Town of River Bend
WWTP Enhancements
River Bend, North Carolina

ADDENDUM NO. 1

TOWN OF RIVER BEND
WASTEWATER TREATMENT PLANT ENHANCEMENTS
DWI PROJECT NO. SRP-W-ARP-0241
DRAWING NO. W-3575-A

ADDENDUM NO. 2

DESIGNED BY:	GJC	PROJECT No.	2022129	SHEET No.
DRAWN BY:	IM/EDN	DRAWING No.	W-3575-A	C1-A
CHECKED BY:	GJC	SCALE	AS NOTED	
		DATE	12/5/2023

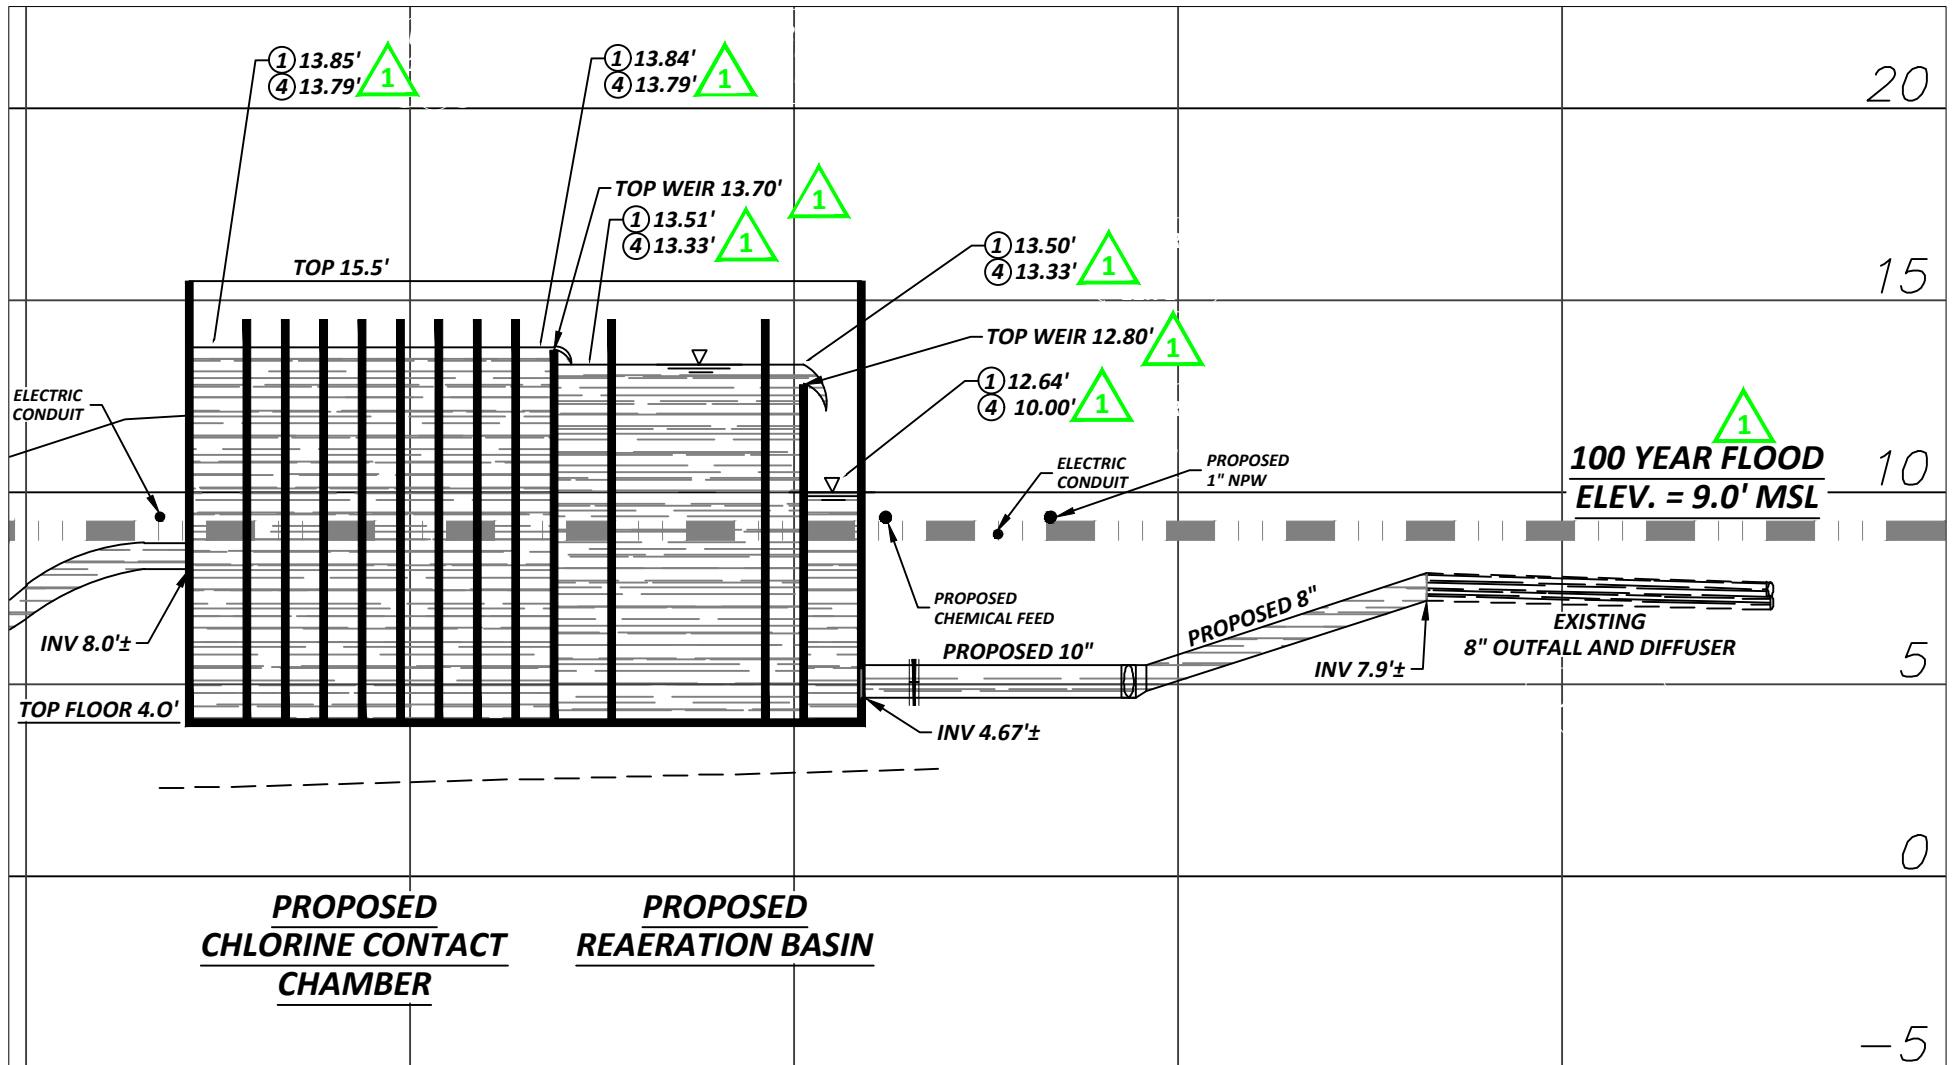
2. SHEET C1 – HYDRAULIC PROFILE

Revise the 100-year flood elevation note as follows:

Attached with this Addendum are two (2) 8.5”x11” drawings of the revisions to Sheet C1 including the 100-year flood elevation outlined above. Revisions are also included to affected weir invert and water surface elevations for the proposed reaeration basin, chlorine contact chamber, and tertiary filter clearwell due to the revised 100-year flood. See page AD2-9 through AD2-10 attached. Full size revised plan sheets will be incorporated into the drawings released for construction.

CHLORINE CONTACT - PLAN AND SECTION

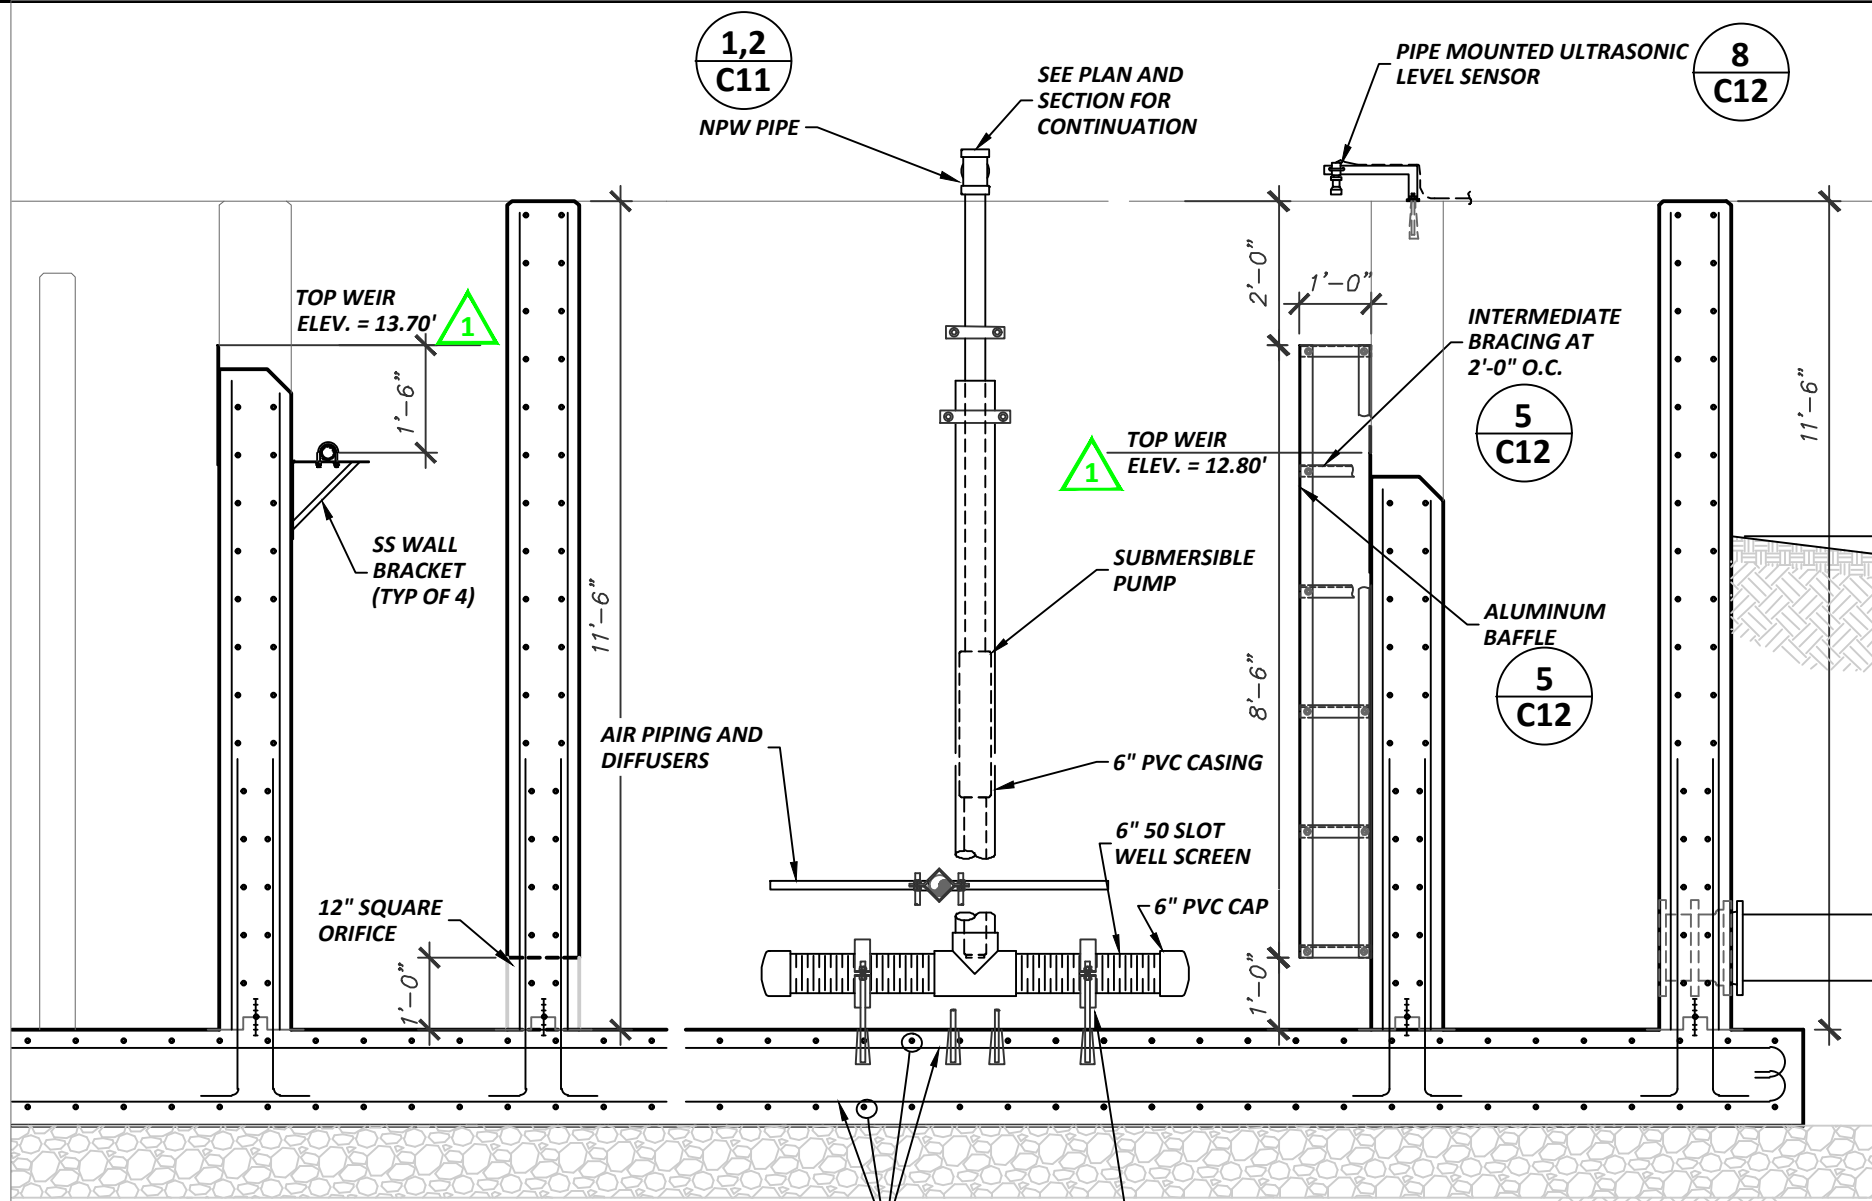
3. SHEET C11 – CHLORINE CONTACT – PLAN AND SECTION

Revise the weir elevations for the proposed chlorine contact chamber as shown on the attached 8.5”x11” drawing. See page AD2-11 attached. Full size revised plan sheets will be incorporated into the drawings released for construction.

1 FIXED WEIR SCHEDULE

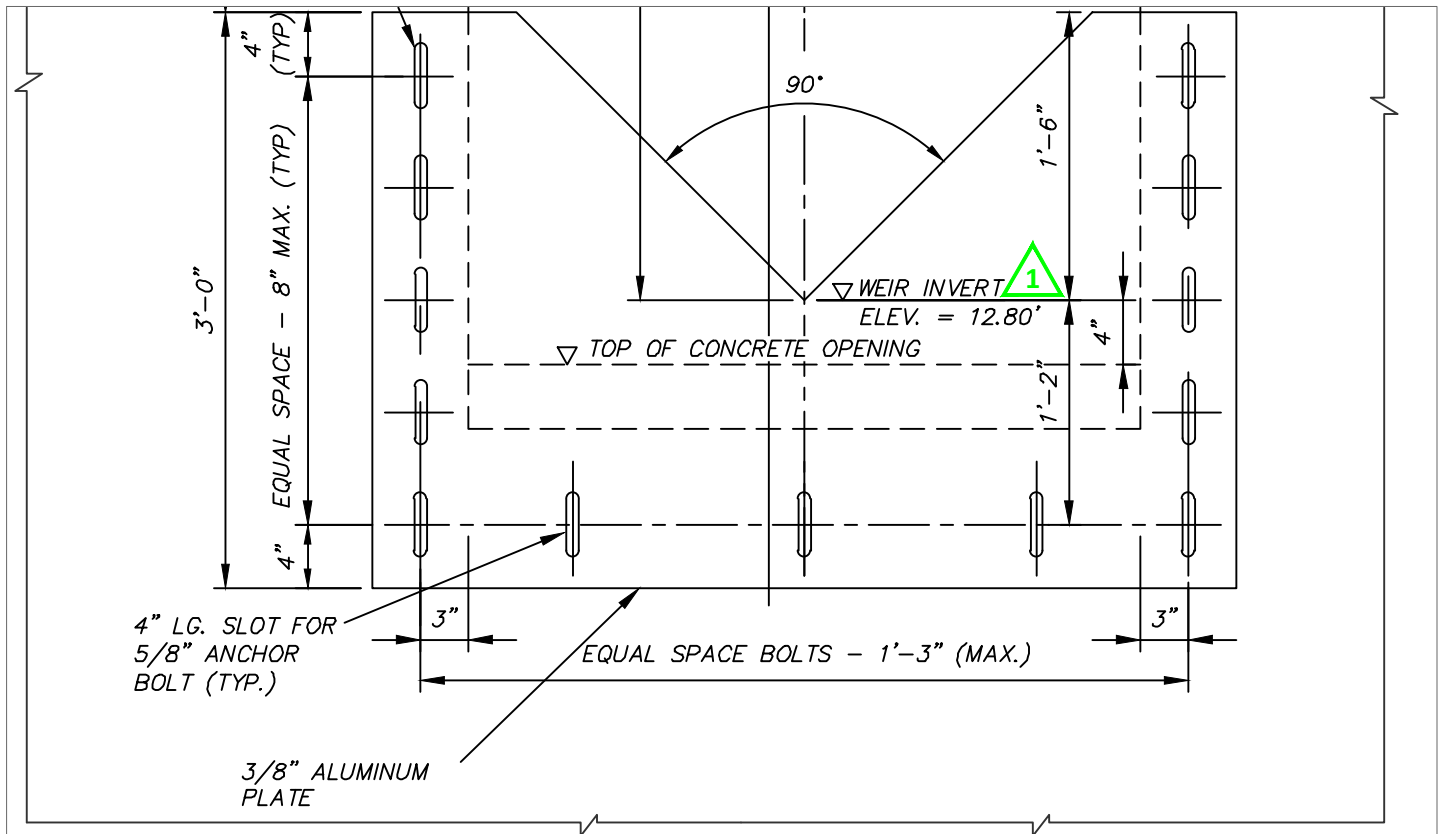
4. SHEET C12 – CHLORINE CONTACT DETAILS

Revise Detail 1 - FIXED WEIR SCHEDULE and Detail 3 – FIXED V-NOTCH WEIR – DETAIL as shown on the attached 8.5”x11” drawing. See page AD2-12 attached. Full size revised plan sheets will be incorporated into the drawings released for construction.

C12

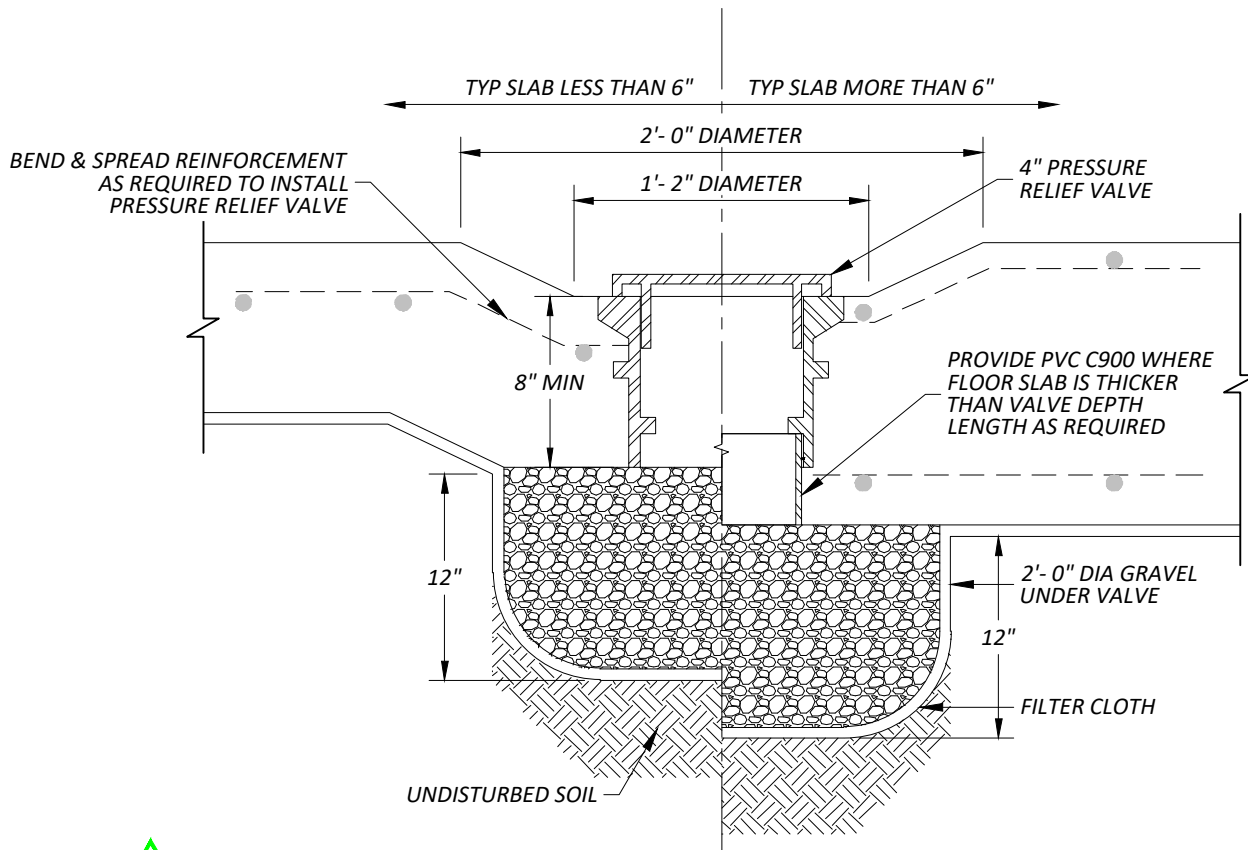
5. SHEET C16 – AEROBIC DIGESTER – PRESTRESSED CONCRETE – ALTERNATE BID

On Section 8 – SLUDGE OUTLET WITH QUICK CONNECT, add an invert elevation of 4.90’ to the sludge outlet wall pipe.

On Detail C – STAIR AND PLATFORM ELEVATION, delete the “4’-0” (MIN)” extended base note. Also revise “~~12” (MIN)~~ REINFORCED CONCRETE SLAB” note.

Attached with this Addendum is an 8.5”x11” drawing of the revisions to Sheet C16 for Section 8 and Detail C as outlined above. See page AD2-13 attached. Full size revised plan sheets will be incorporated into drawings released for construction.
